Attachment 4 – Summary of Changes to Draft Parramatta Development Control Plan.

This document outlines the changes recommended to be **supported** and able to be progressed with the Draft ‘Harmonisation’ Parramatta Development Control Plan (DCP) at this time (post exhibition prior to finalisation).

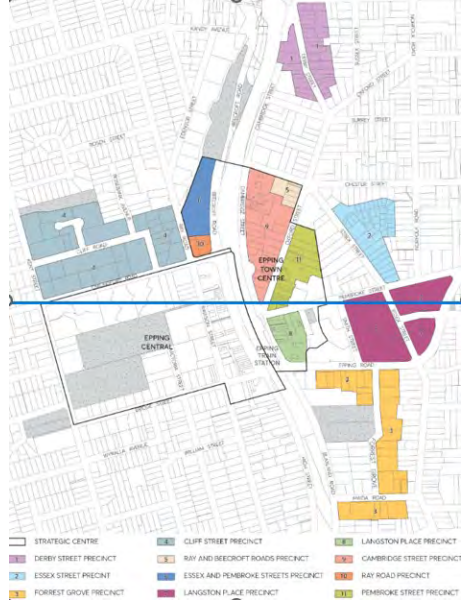
<p>Table 5.3.4.1 – Type of Tree Application required. The draft Harmonisation DCP</p>	<p>Amendment made to Table 5.3.4.1 – Type of Tree Application required under Section 5.3.4 – Tree</p>	<p>Proposed amendment required to provide clarity on when an application must be made</p>

DCP Section	Details	Proposed amendment	Justification			
	<p>specifies the tree application required in a table format.</p> <p>Additional wording is proposed to clarify when an application may not be required, such as tree work prescribed as exempt in the draft Harmonisation DCP.</p> <p>This amendment is proposed to provide further clarity for 'other land -tree removal or pruning' application requirements, particularly to differentiate consent requirements from the exempt tree work prescribed in the draft Harmonisation DCP.</p>	<p>and Vegetation Preservation in <u>red text and underlined</u> as below:</p> <table border="1" data-bbox="936 331 1509 568"> <tr> <td data-bbox="936 331 1099 568"><i>Other land - tree removal or pruning</i></td> <td data-bbox="1099 331 1413 568"><i>Removal or pruning of trees (<u>considered pruning in excess of exemptions prescribed in DCP section below</u>) not subject to <u>Biodiversity Offsets Scheme</u></i></td> <td data-bbox="1413 331 1509 568"><i>Tree Permit</i></td> </tr> </table>	<i>Other land - tree removal or pruning</i>	<i>Removal or pruning of trees (<u>considered pruning in excess of exemptions prescribed in DCP section below</u>) not subject to <u>Biodiversity Offsets Scheme</u></i>	<i>Tree Permit</i>	<p>for the removal or pruning of a tree under the requirements of the draft Harmonisation DCP.</p>
<i>Other land - tree removal or pruning</i>	<i>Removal or pruning of trees (<u>considered pruning in excess of exemptions prescribed in DCP section below</u>) not subject to <u>Biodiversity Offsets Scheme</u></i>	<i>Tree Permit</i>				
	<p>Additionally, Table 5.3.4.1 – Type of Tree Application required contained references to “HLEP” within the first two rows. As this references one of the legacy LEPs inherited during the Council’s amalgamation of 2016, it is required that these references are updated to the new Parramatta LEP 2023.</p>	<p>Update the first two rows of Table 5.3.4.1 – Type of Tree Application required to amend references from HLEP to <u>Parramatta LEP 2023</u>.</p>	<p>Proposed amendment is minor in nature and does not constitute a change in policy position. The proposed amendment is required to ensure that the draft DCP references the correct local environmental plan.</p>			
<p>5.4.3 All-Electric Buildings</p>	<p>Controls regarding all electric buildings have been introduced as part of harmonisation process bringing the draft Harmonisation DCP in line with the scheduled changes to <i>State Environmental Planning Policy (Sustainable Buildings) 2022</i> due to come into effect October 2023.</p> <p>The current wording under C.01 of Section 5.4.3 – All-Electric Buildings would cause confusion regarding development types to which these controls apply. It is proposed to</p>	<p>Amend C.01 of Section 5.4.3 – All-Electric Buildings in <u>red and underlined</u> as follows to remove any ambiguity of applicable development types:</p> <p>C.01 <u>New development that is:</u></p> <p>a) <u>non-residential development that is State Significant development specified in State Environmental Planning Policy (Planning Systems) 2021, Schedule 1, Section 13-15, or</u></p> <p>b) <u>commercial development</u></p> <p>All non-residential development that is State Significant Development specified in State Environmental Planning Policy (Planning</p>	<p>Proposed amendment is minor in nature and does not constitute a change in policy position. The proposed amendment is required to ensure controls are not misinterpreted and ensures Council’s intent will be reflected during the Development Assessment stage.</p>
